# SHOP DRAWING TRANSMITTAL

Project: Turnbull School Music Room Addition Project No: 1705  
Date: October 18, 2018  
To: TALCO Building Innovations Ltd.  
Attn: Farah Bano (fbano@tal-co.com)  
From: Reinhard Vogel

Division 22 – Plumbing Fixtures

Drop In Sink LBS4607-1

**DROP IN SINK: LBS4607-1**

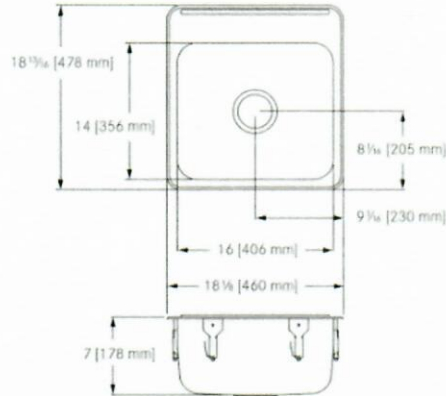
- 3.1 Unit to be high efficiency per specs 18.1
- 3.2 High arch faucet to be submitted to go with the sink

**HIGH ARCH FAUCET TO BE SUBMITTED**
